**PUR-1270  
ADDENDUM NO. 4  
INVITATION TO BID**

**CONOCOCHEAGUE TREATMENT PLANT ENR UPGRADE**

**DATE: Thursday, May 19, 2016**

# CONNECTION DETAIL NO. 21

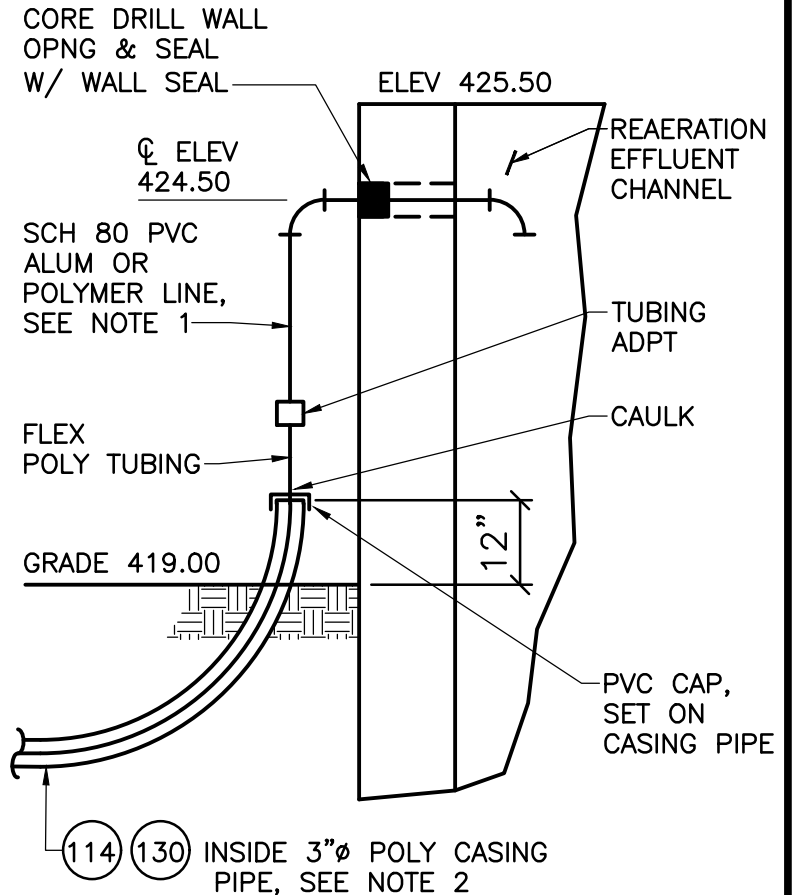
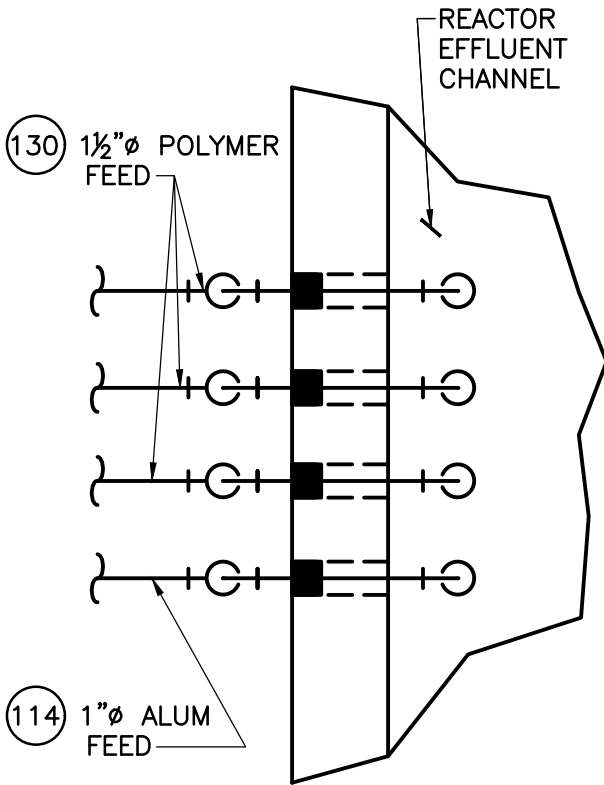
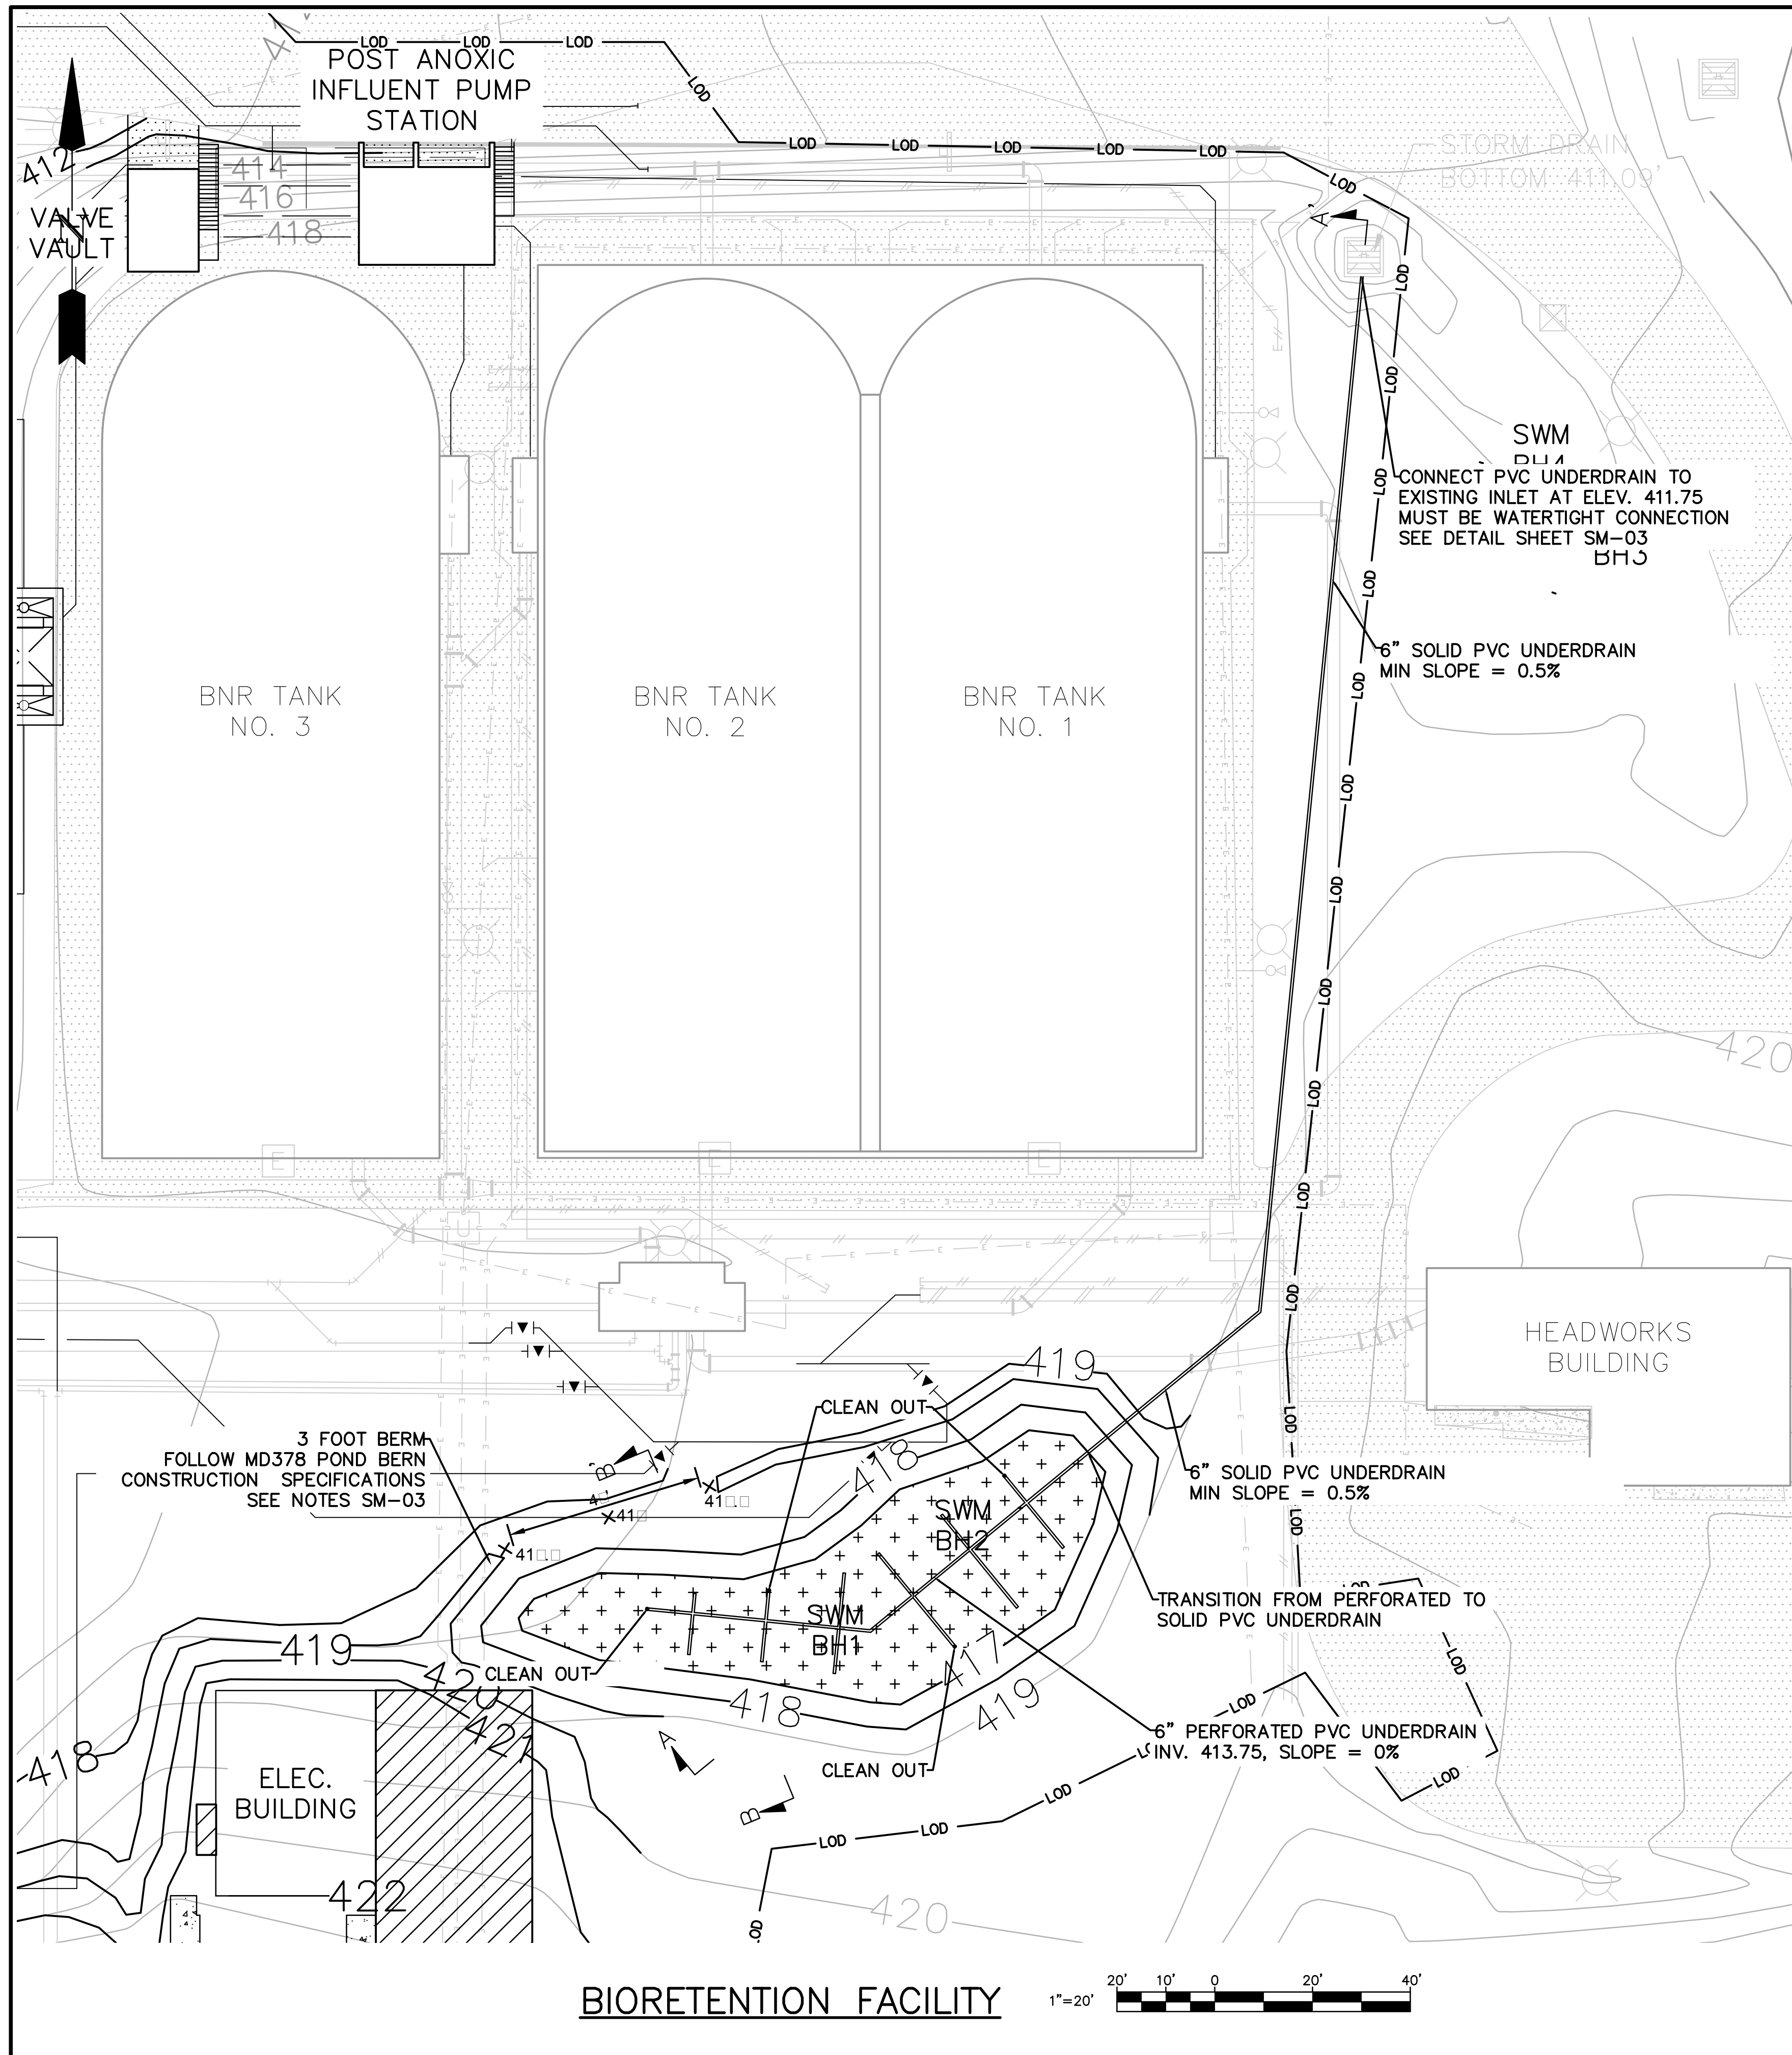
**ITEM NO. 22:** Inquiry: Yard Piping Line 144-8" DI Post Anoxic Tank Drain ties-in into existing Line 6 (30" DIP). Please provide connection detail for this tie-in.

Drawing No. C-3, Proposed Yard Piping Plan – Where Line No. 144 ties into Line No. 6, provide a 30”x6” saddle for making the connection.

Drawing No. C-7, Yard Piping Connection Details - **DELETE** Connection Detail No. 21 and **REPLACE** with revised Connection Detail No. 21, attached to this Addendum No. 4.

Response: See Drawing C-7 attachment to this Addendum.
